PROJECT TITLE G.G.B. Apartments TYPE OF SUBMITTAL Drainage/Grading

RE: REVISED DRAINAGE PLAN FOR G.G.B. APARTMENTS
(K-19/D49) REVISION BLOCK DATED JANUARY 12, 1987

DRAINAGE / GRADING PLAN
 g.g.b. apts.
 317 pennsylvania n.e.

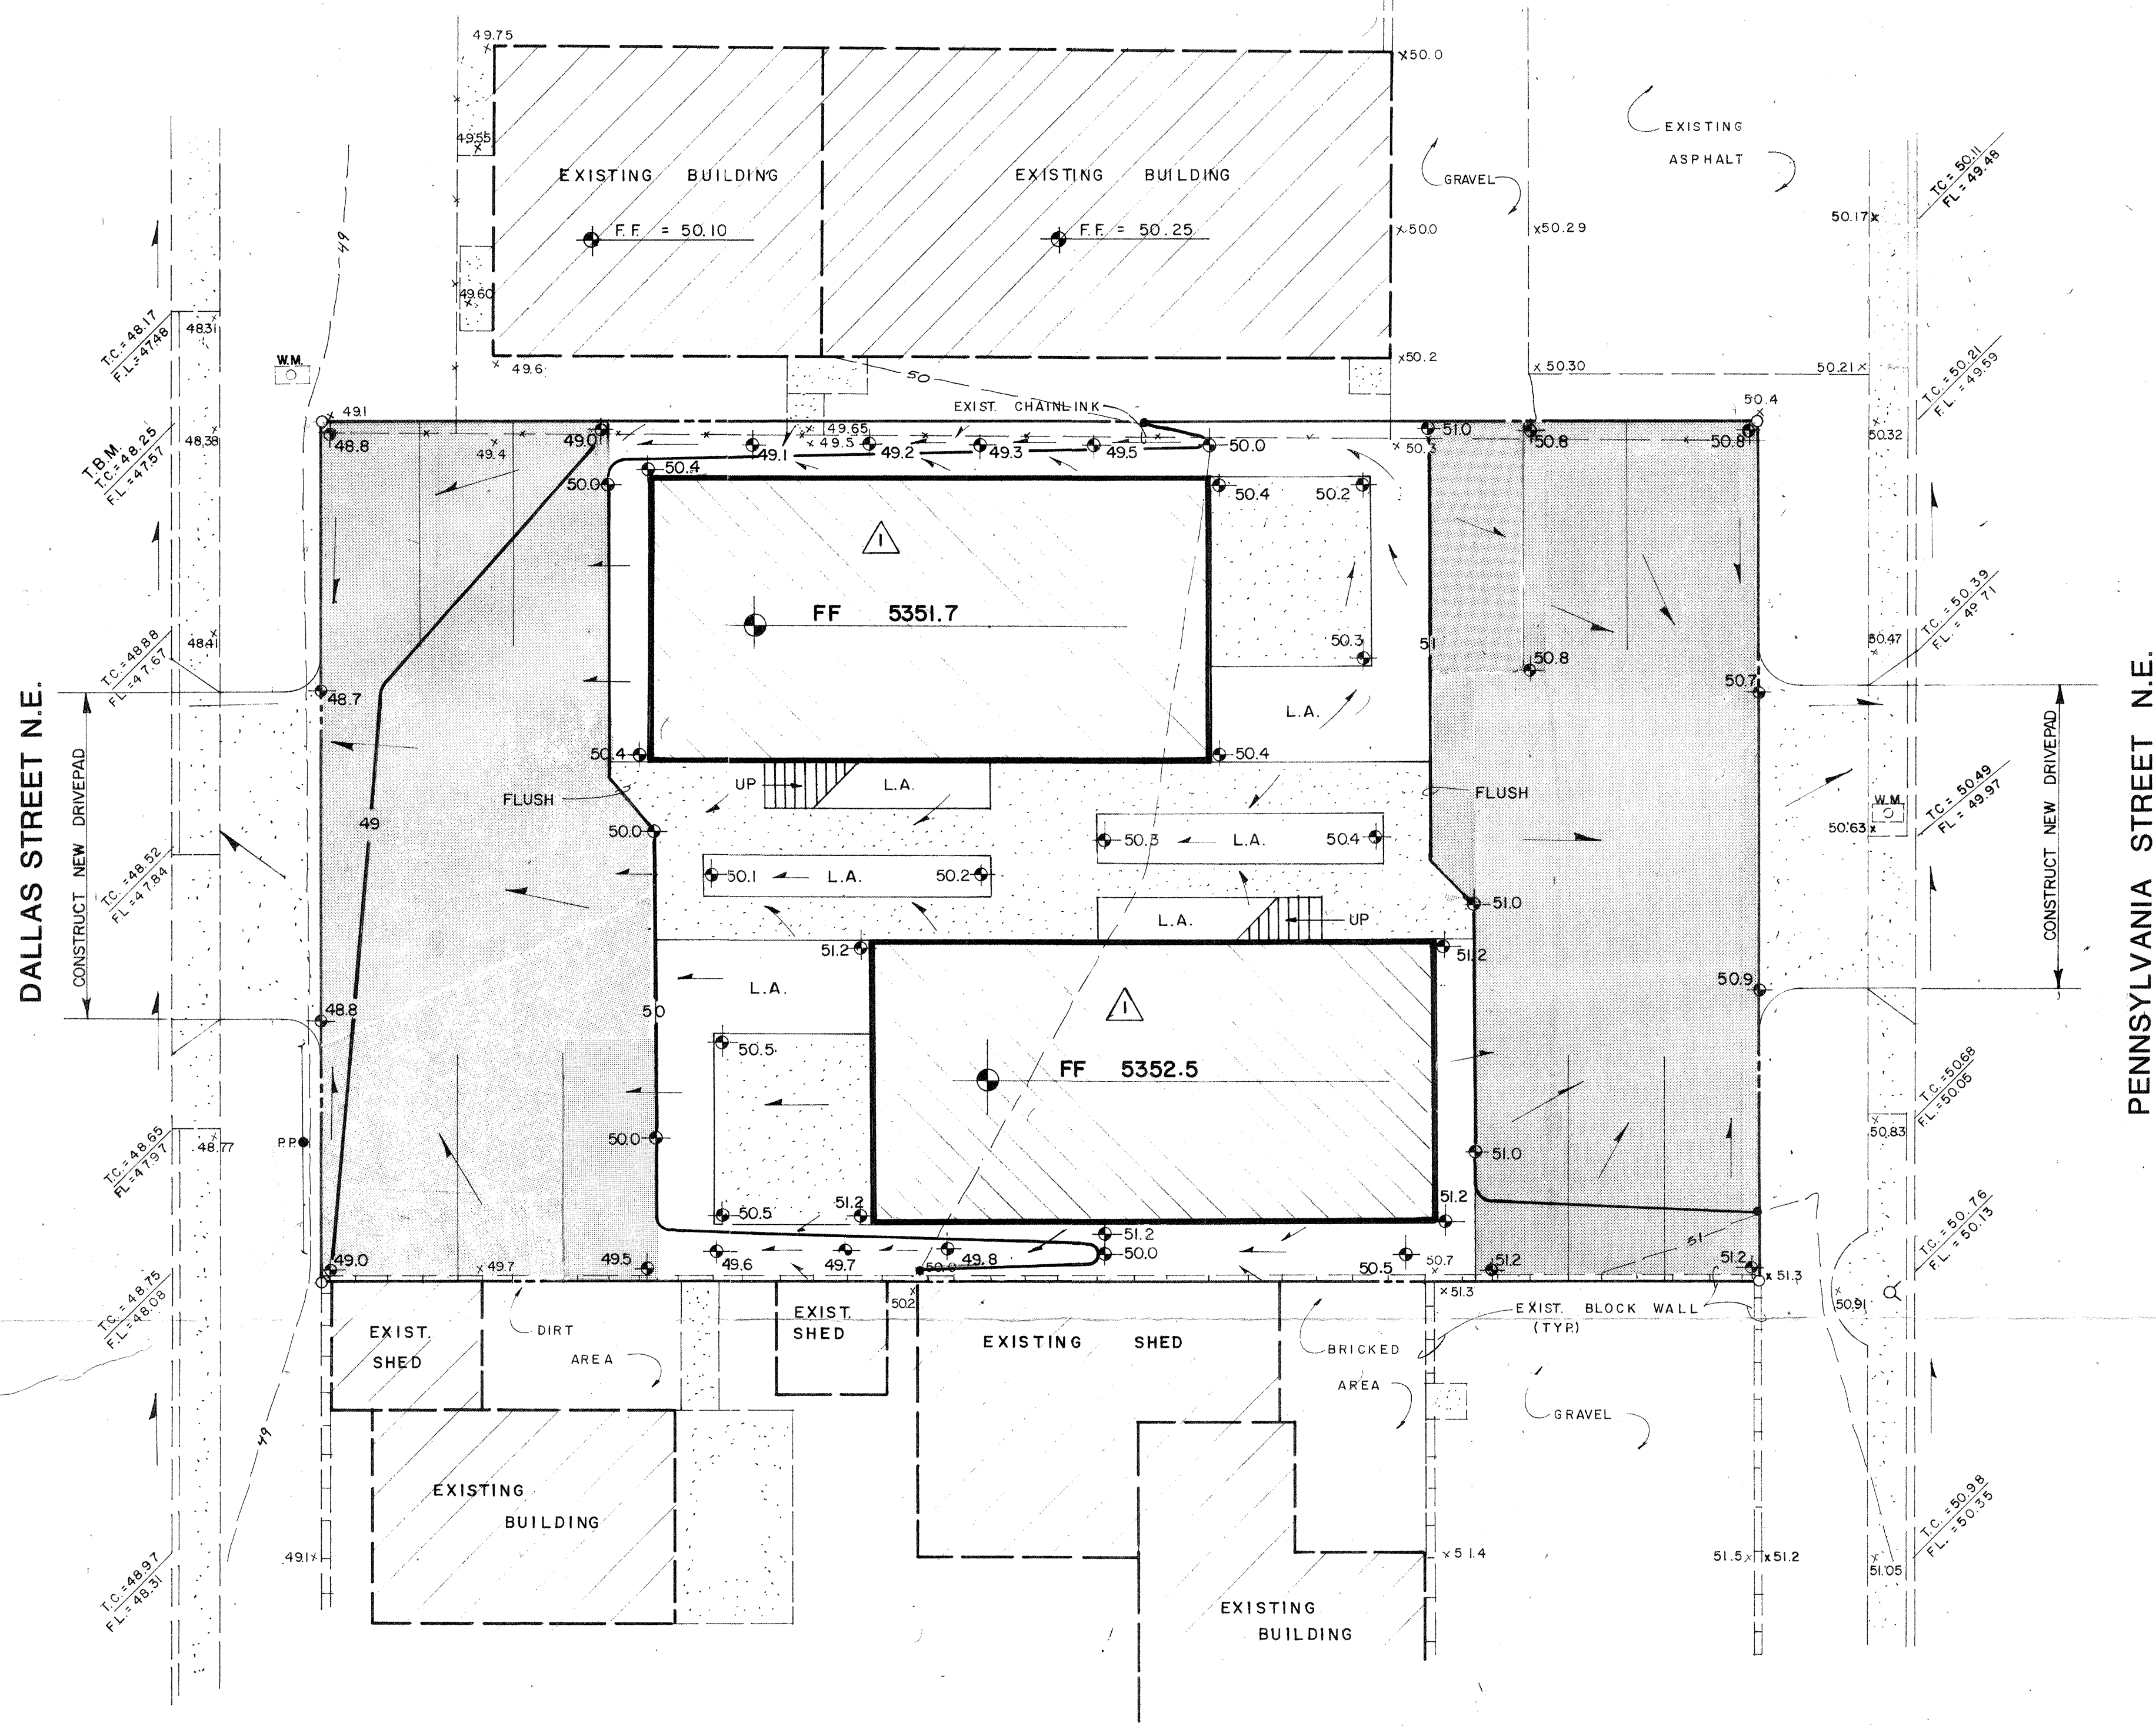
Based on the information provided on your resubmittal of January 13, 1987, revisions as indicated are acceptable.

Please attach a copy of this approved plan to both sets of construction drawings submitted for building permit prior to Hydrology sign-off.
